IEEE P802.3dd 10BASE-T1L Droop and Return Loss

- ▶ This presentation is in relation to the following comment

146.5.4.2 24

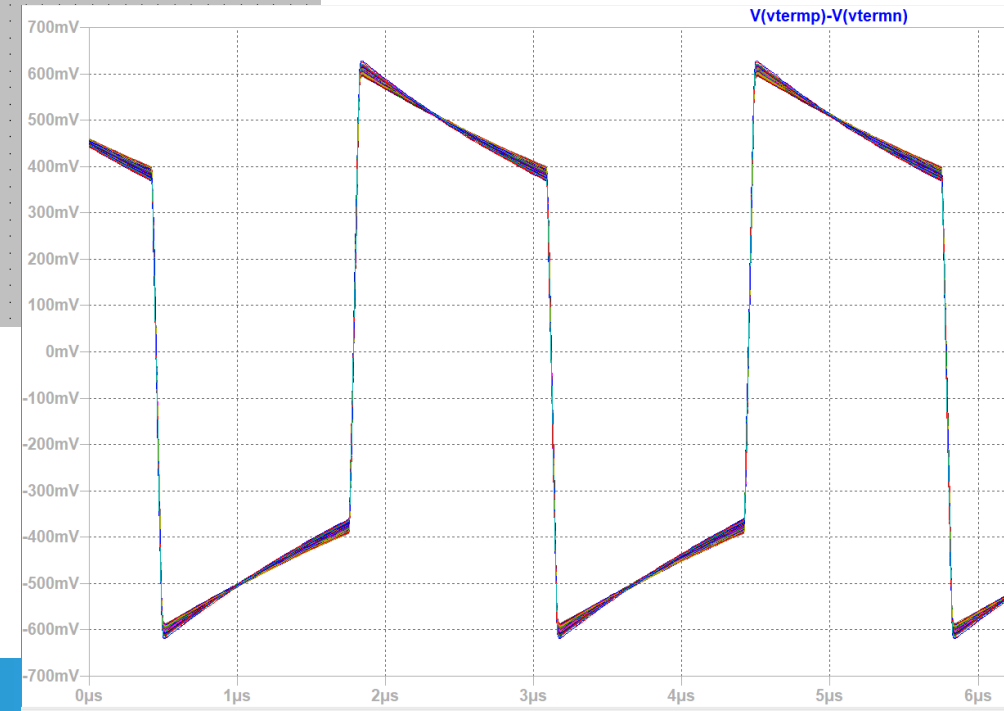
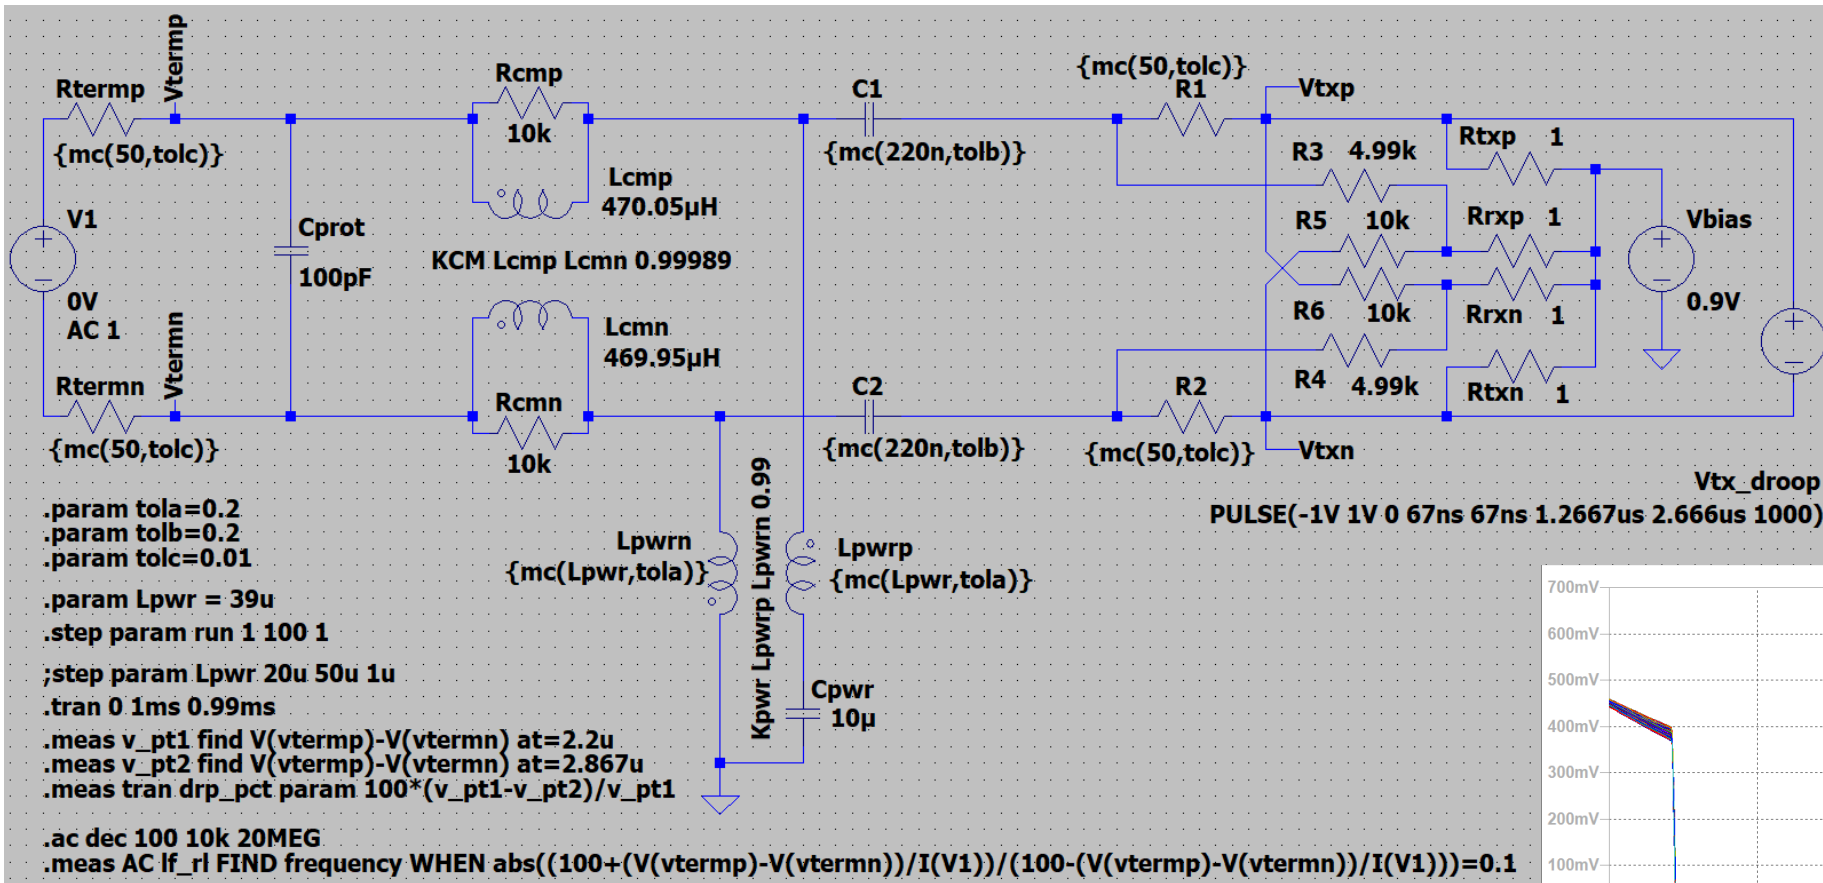
Implementers indicate that receivers are insensitive to droop of 30%, and that it improves economic feasibility for 10BASE-T1L transceivers with inline power.

Change "25%" to "30%" at P26 L24

Return Loss – Simulation

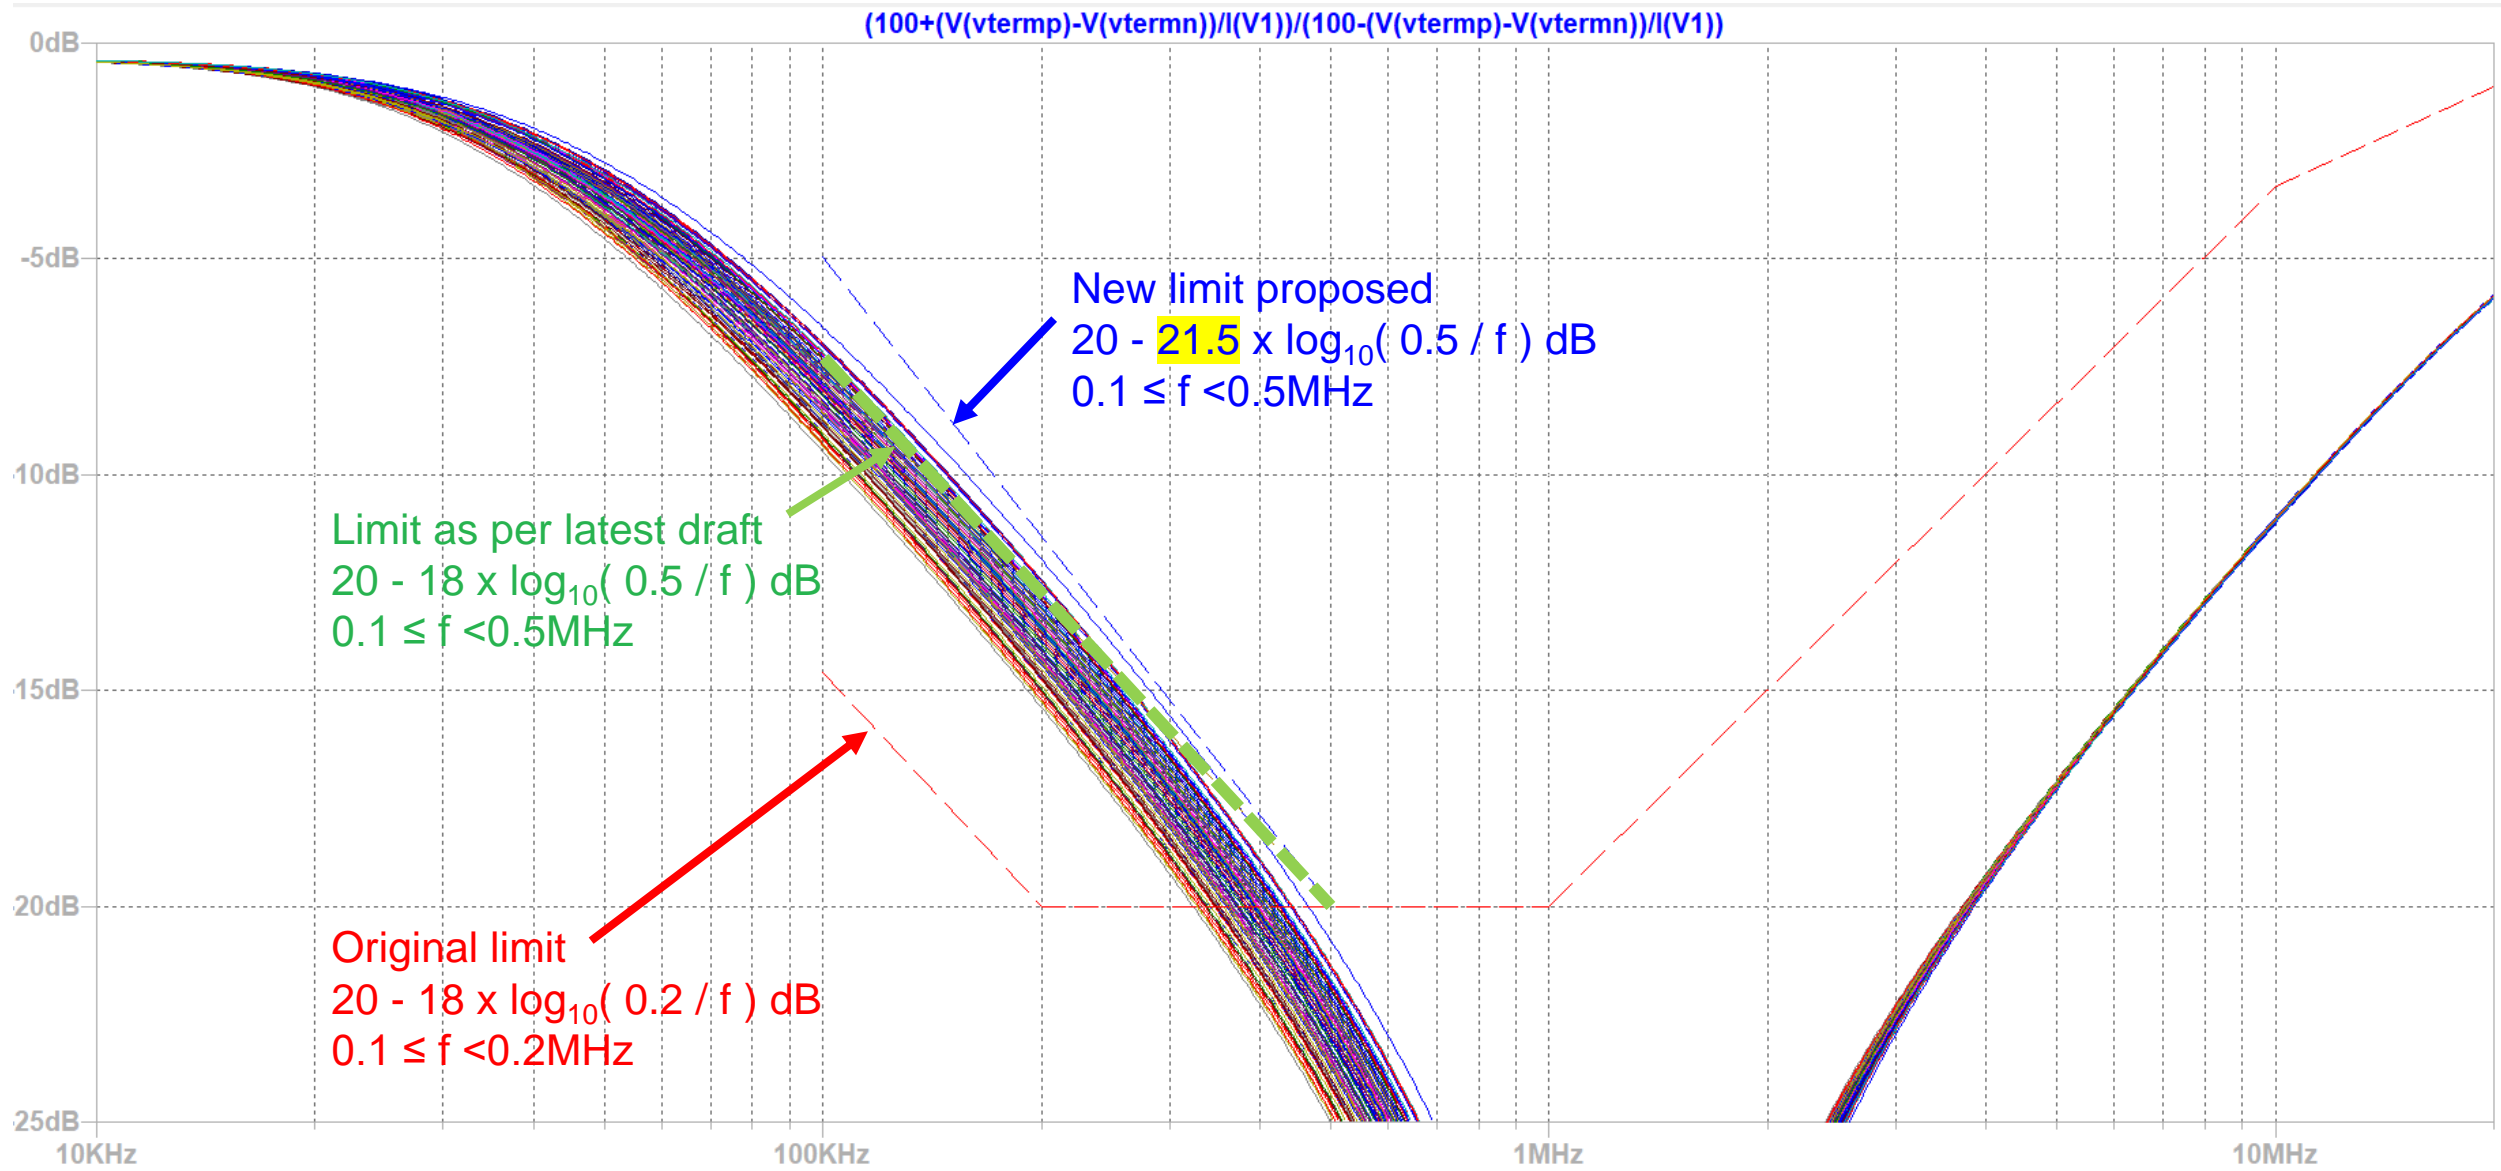
- ▶ We have included some Monte Carlo simulation results for return loss for the case where droop approaches the 25% limit
- ▶ We propose a small change to the return loss limit slope of the low frequency section to ensure the return loss limit is consistent with the droop limit of 25%

Return Loss Measured, EVAL-ADIN1100EBZ, MSD7342-393MLC, 2x 39uH, coupled, 156uH Diff.

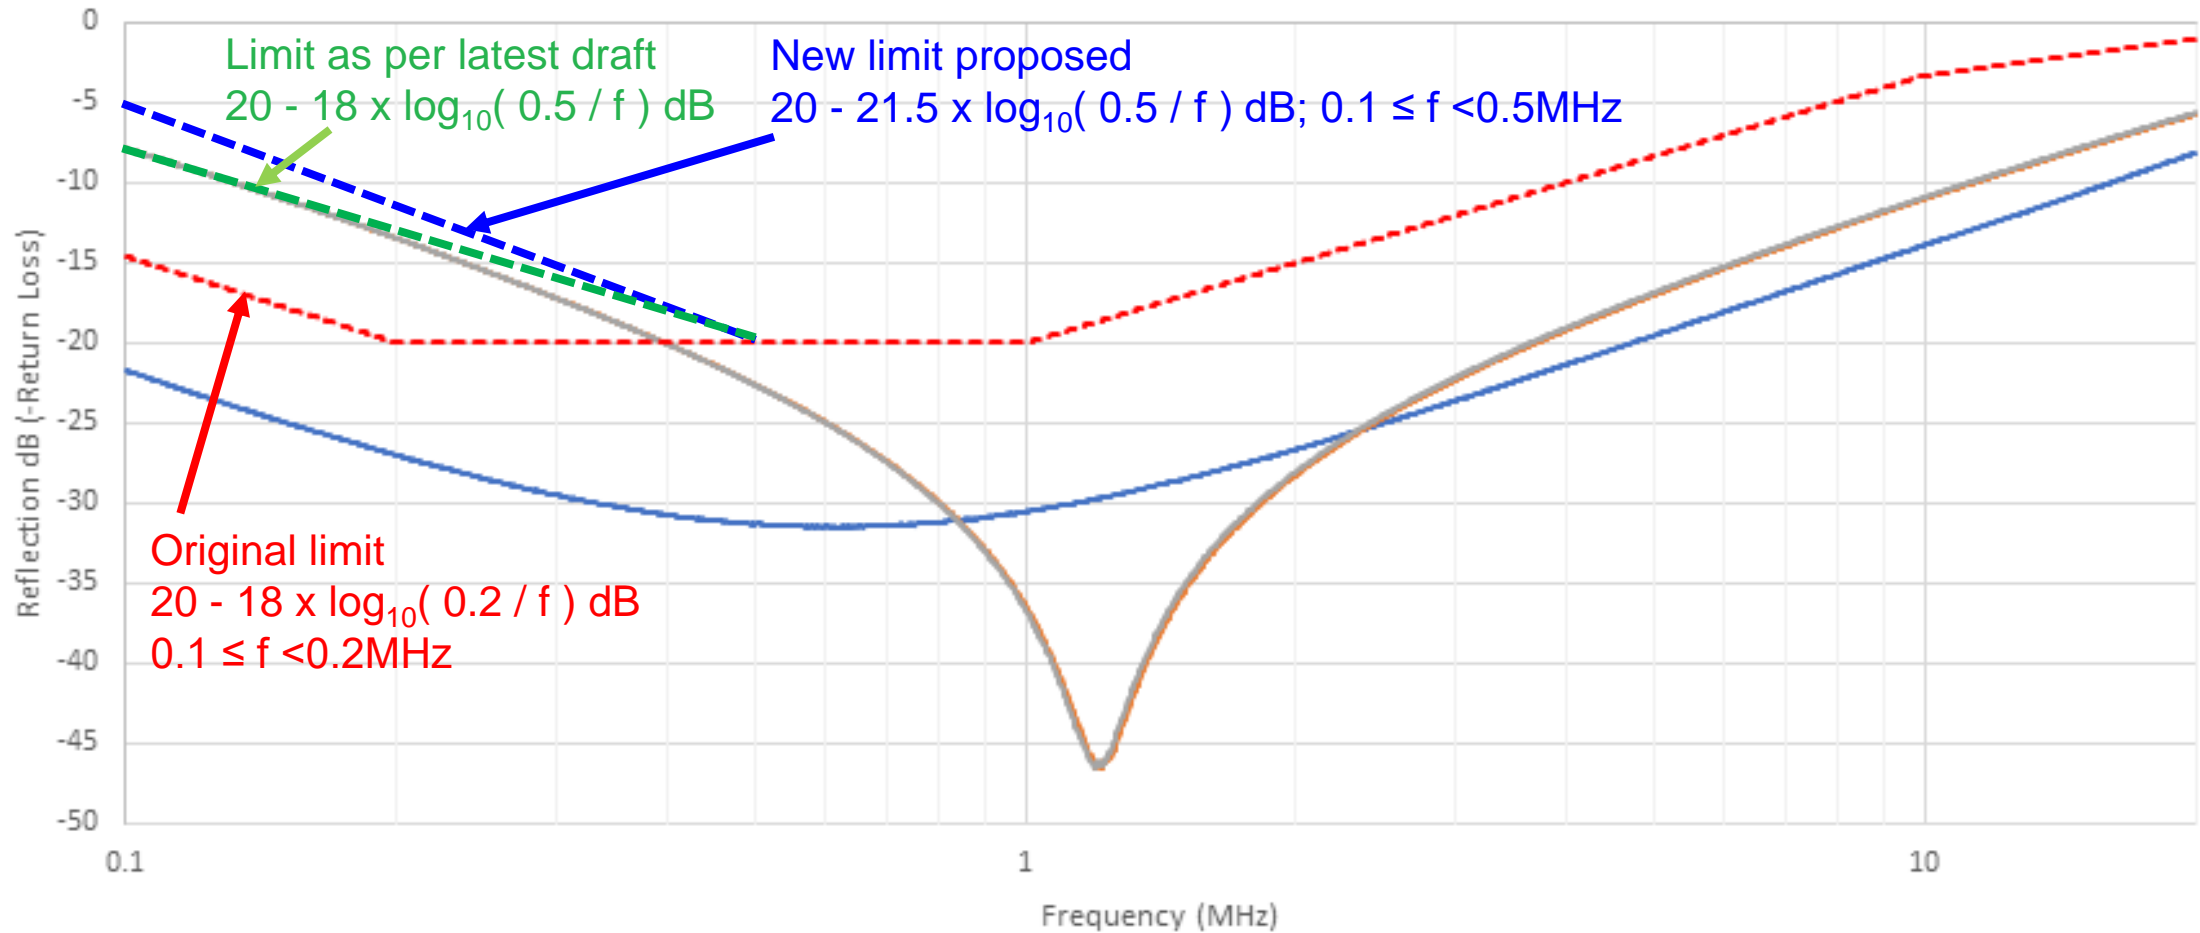
- A small change to the return loss limit slope and initial value @100kHz from 7.42dB to ~5dB is required to be consistent with the 25% droop limit
 - Keeping the same intercept of 500kHz at -20 dB already agreed

► Suggested Remedy: Change 146.8.3, including additional equation 146-17a to read (yellow highlight shows changes):

When a Clause 104 Type E PSE or PD PI is encompassed within the MDI, the MDI return loss (RL) shall meet or exceed Equation (146–17a) for all frequencies from 100 kHz to 20 MHz (with 100 Ω ± 0.1% reference impedance) at all times when the PHY is transmitting data or idle symbols.

$$\text{Return Loss } (f) \geq \left\{ \begin{array}{ll} 20 - 21.5 \times \log_{10} \left(\frac{0.5}{f} \right) \text{ dB} & 0.1 \leq f < 0.5 \text{ MHz} \\ 20 \text{ dB} & 0.5 \leq f \leq 1 \text{ MHz} \\ 20 - 16.7 \times \log_{10} (f) \text{ dB} & 1 < f \leq 10 \text{ MHz} \\ 3.3 - 7.6 \times \log_{10} \left(\frac{f}{10} \right) \text{ dB} & 10 < f \leq 20 \text{ MHz} \end{array} \right\} \quad (146-17a)$$
